SERVICE BULLETIN

Inspection and/or replacement of the valve push-rod assy., rocker arm left and rocker arm right for ROTAX® Engine Type 912 i, 912 and 914 (Series)

ATA System: 72-30-00 Cylinder head

MANDATORY

Fig. 1
Visual inspection

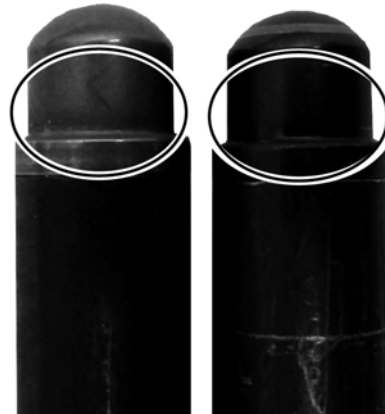
Perform visual inspection of all push-rod ball sockets on all cylinder.
 Check for color. See Fig. 1.

Color	Evaluation
Silver surface	Valve push-rod is OK. No further action required for this valve push-rod.
Black surface	Valve push-rod is NOT OK. See section. 3.1.3) Replacement of affected parts.

Fig. 2

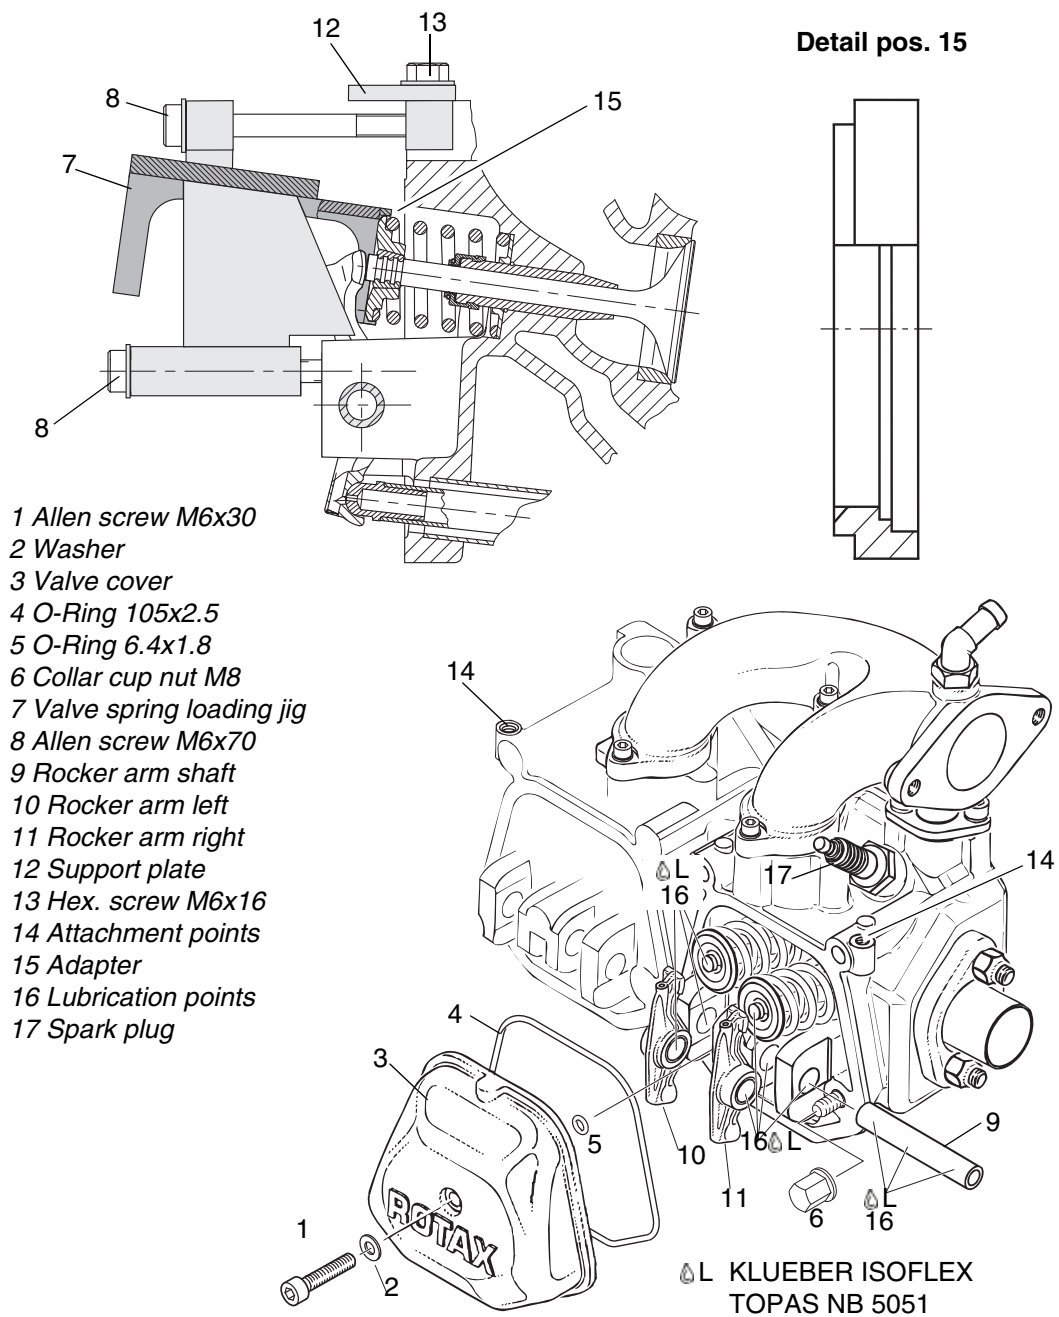
Step	Procedure
1	Loosen Allen screw (1) M6x30 with washer (2) from valve cover (3), and remove it together with large and small O-rings (4) and (5).

Step	Procedure
3	Attach the support plate (12) to the valve spring loading jig part no. 877387 (7) with 2 hex. screws (13) M6x16 at the attachment points (14) on the cylinder heads.
4	Put adapters (15) on the valve spring loading jig.
5	Attach the valve spring loading jig on cylinder head and support plate with 2 Allen screws (8) M6x70 and depress both valves with 3 turns.

Step	Procedure
1	Clean the sealing surface of cylinder head and valve cover with a suitable lint-free cloth or equivalent.
2	Insert new O-ring (4) 105x2.5 and O-ring (5) 6.4x1.8 into the valve cover (3).
3	Fit valve cover.

Between the valve covers a gap of min. 0,1 mm (.004 in.) must remain. The covers must not touch each other.

Step	Procedure
4	Tighten the new Allen screw (1) M6x30 with washer (2) to 10 Nm (89 in.lb).

Fig. 3

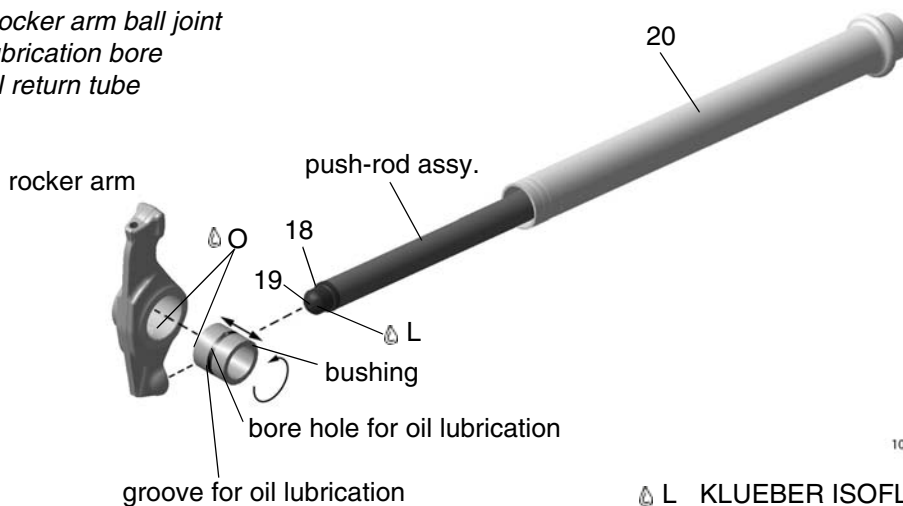
Step	Procedure
6	This will relieve the pressure from both hydraulic tappets. Now the rocker arm shaft (9) may be easily pulled out. Lift out both rocker arms (10) and (11).
7	Replace only affected parts as per section 2.3 . See also Fig. 3 .
8	Apply KLÜBER ISOFLEX TOPAS NB 5051 (16) on both push-rod ball sockets and contact areas of rocker arm and slide push-rod into the oil return tube (20).
9	Check bushing and rocker arm shaft according to latest Maintenance Manual Heavy.
10	Put oil on the rocker arm bushing.
11	Place rocker arm left (10) and rocker arm right (11) in cylinder head, apply KLÜBER ISOFLEX TOPAS NB 5051 (16) on rocker arm shaft (9) and insert it into its bearing support.
12	Loosen valve spring loading jig and support plate.
13	When removing the valve spring loading jig, make sure the adapter rings (15) do not jam on the valve spring retainer.
14	NOTE: Only when you have an Criterion B) Spare parts affected engine and only if engine is equipped with collar cap nuts M8 wrench size 13: Mount collar cap nut (6) according to latest Maintenance Manual Heavy or SI-912-025/SI-914-026/SI-912 i-010.
